II. AMENDMENT TO THE DRAWINGS

REMARKS

OATH/DECLARATION

a) Operation with Bi-Stable Switch

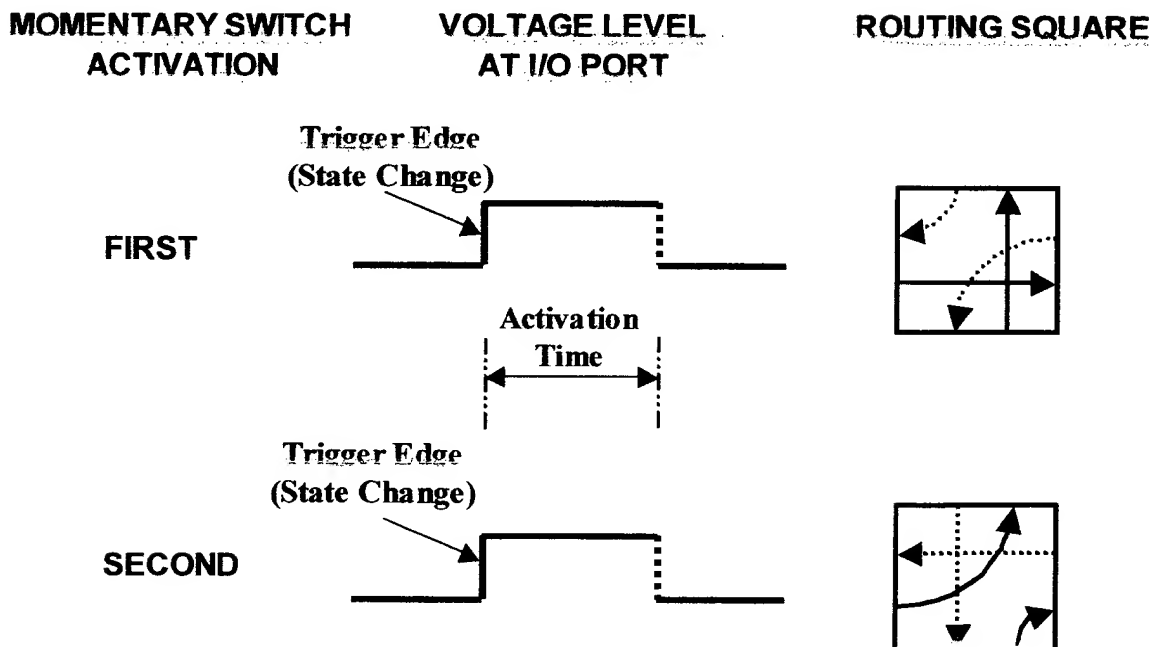
As explained in the amendment to the specification set forth in item 14, when a keypad switch (i.e., momentary switch) is used, successive activations of a momentary switch will toggle a corresponding routing square between its two states. Such operation is inherent in the description of the routing square indicated in Figure 2, and would be obvious to one skilled in the art. As is well known in the art, a typical method of detecting a switch closure with a CPU is to connect switches to input ports controlled by the CPU. When a switch is pressed, it closes a circuit, which in turn changes the electric voltage level at one or more input ports of the microprocessor, thus permitting the CPU to detect that the switch has been depressed. This same method may be used regardless of whether momentary or bi-stable switches are employed in a design. To demonstrate how the routing square is activated by both a bi-stable switch, and a momentary switch, the Examiner is referred to the following two illustrations:

The function of the switch as explained in the '037 patent is to activate the associated routing square. When depressed, the closure of a momentary switch is detected by the CPU. As a result, the CPU first determines which routing square is associated with the switch, and next

uses this information to change the state of the routing square to the other of its two states. Once the state of the routing square is recorded by the CPU, it will stay in this state until such time that the associated switch is pressed again. In this vein, it is the detection of the closure of the switch, and not the actual position, that is important in transitioning a routing square between its two states. This is why momentary or bi-stable switches may be used interchangeably in the context of the '037 patent disclosure. Once the closure is detected, the position of the switch is unimportant.
